# 4R70W/4R70/75E

## Interchange Information

### Center Support

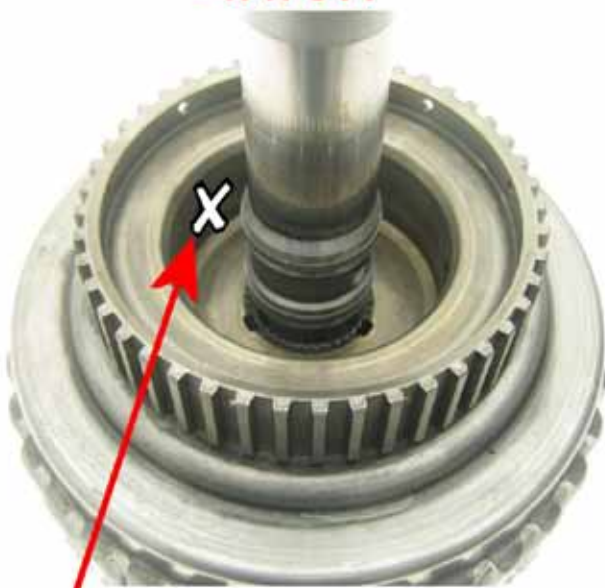
To make room for the turbine speed sensor, the 4R70E/75E center support has an extra notch cut out. If you install a 4R70W support in a 4R70E/75E case, the turbine speed sensor will not install all the way into the case.

If you are in a pinch, grinding a notch into the support to make room for the sensor will not pose a problem.

### Forward Drum

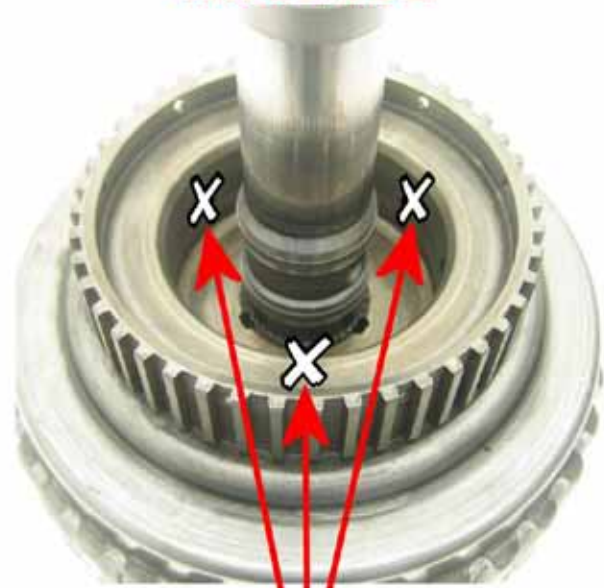
2004-on, forward drums have three clutch apply holes, 120° apart, verses the earlier version having only one. This design change is cosmetic and will not affect forward clutch apply if interchanged. The 4R70/75E drum will fit on all year models.

### Intermediate Mechanical Diode Sprag

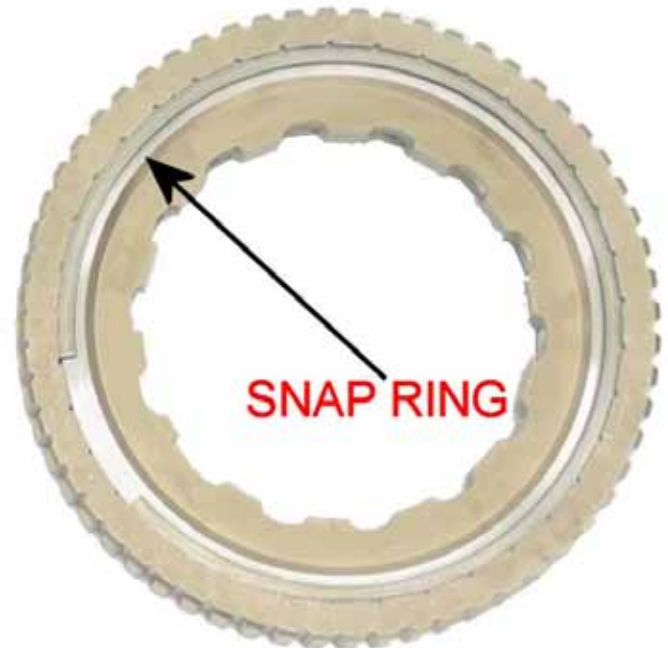
In 2007, Ford introduced a new design mechanical diode. They increased the number of ratchet teeth in the diode which should increase holding strength. At the time of printing this manual, there have been no reports of premature failure.

The new diode has a snap ring that holds the element retainer in place instead of the earlier pressed design. Height dimensions have changed slightly where the snap ring rides on the reverse input/OD drum.

The new design diode supersedes the previous design, and when used on any diode-style drum, will increase the clearance between the inner race and the snap ring by about 0.020", this is a normal clearance by design. An aftermarket-designed spiral snap ring should be used in place of the stock snap ring to prevent snap ring failure.

### Harness Connector Changes

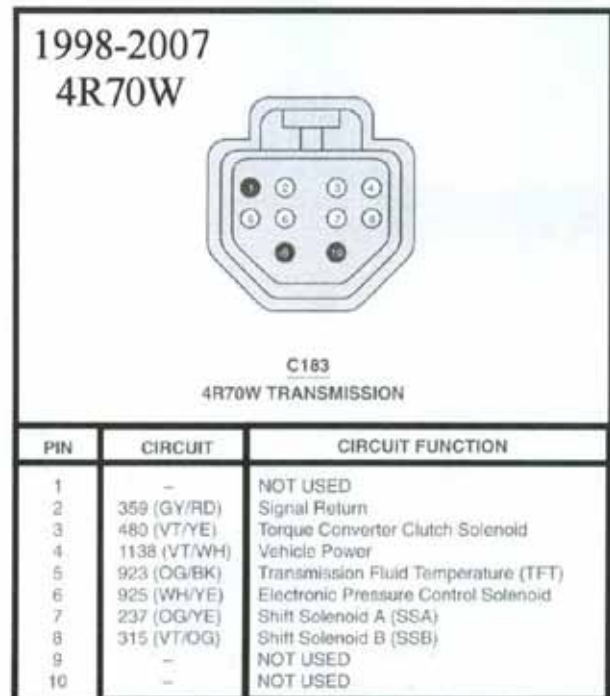
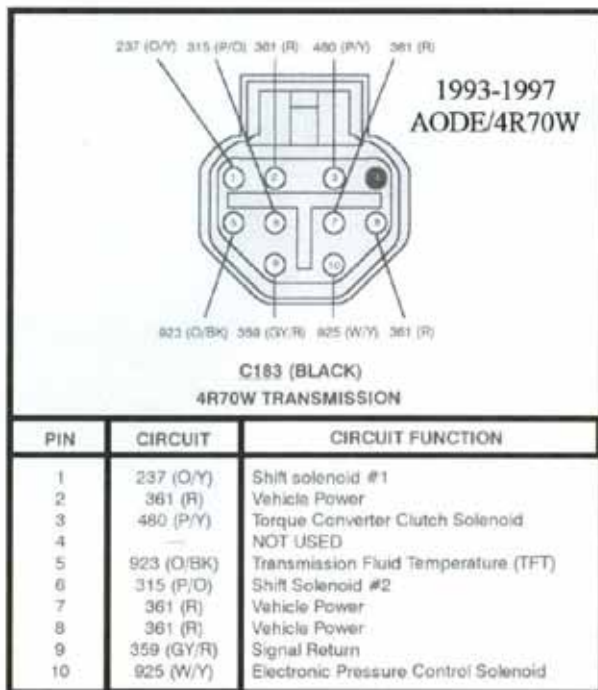
Use the diagrams to make sure you are using the correct connector for your application. The diagrams shown are the vehicle side of the harness. From 1993-1997, the transmission connector is white with soft wiring built into the connector.

From 1998-on, the connector is black in color and uses the separate hard plastic harness. Solenoids will not interchange due to connection differences.

**NOTE: Installing the wrong wiring harness can create multiple codes and erratic shifts.**

### Stator Support

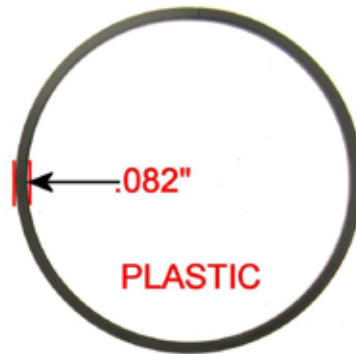
The stator supports are identical in hydraulic design but there is an important difference in the forward sealing ring lands. The 4R70E/75E uses a plastic ring that is much thinner than the 4R70W cast iron design.

The outer dimensions of the two rings are identical so as long as the correct rings are used, the stator supports can be interchanged.

The other difference is the forward clutch feed hole. Ford changed the machining process for the forward clutch apply hole and turned it into a slot instead of a round hole. This is strictly cosmetic and will have no effect on forward clutch apply if interchanged.

### Sun Shell and Forward Sun Gear (continued)

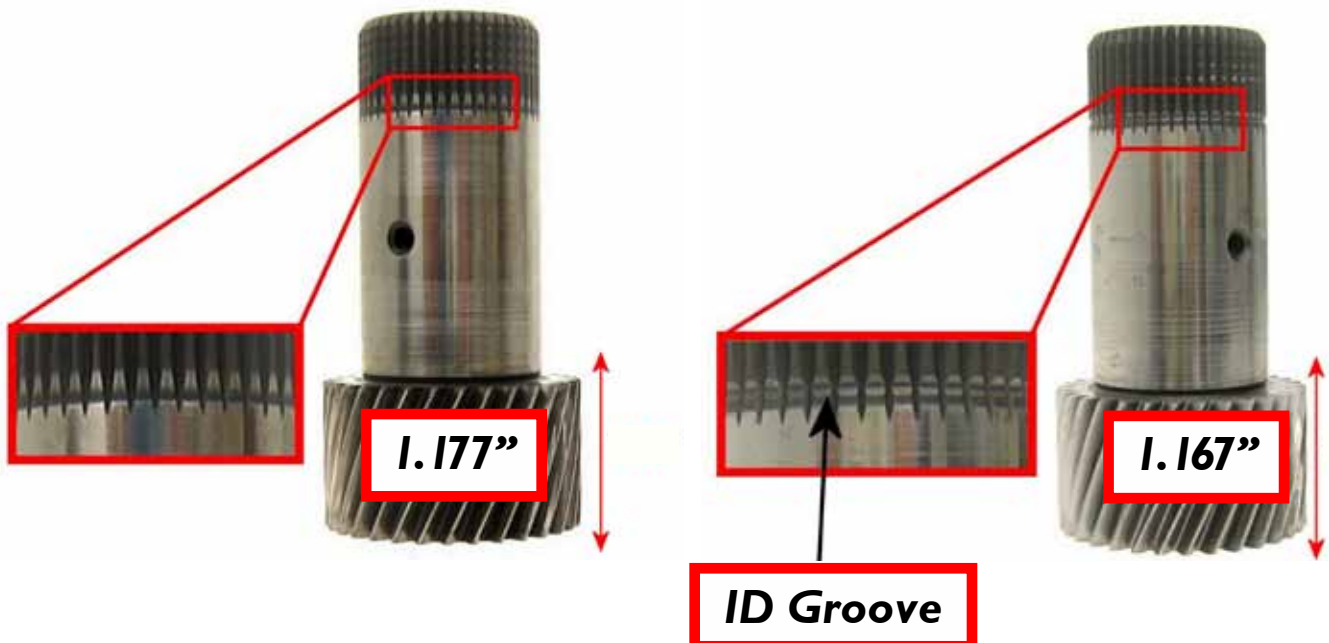
The sun shell, bearing, and forward sun gear must be changed as a set if changing over to a 4R70W or the end play will be incorrect. Ford sells this complete service kit under part # 4L3Z-7D234-AA.

**Thicker two piece bearing.**
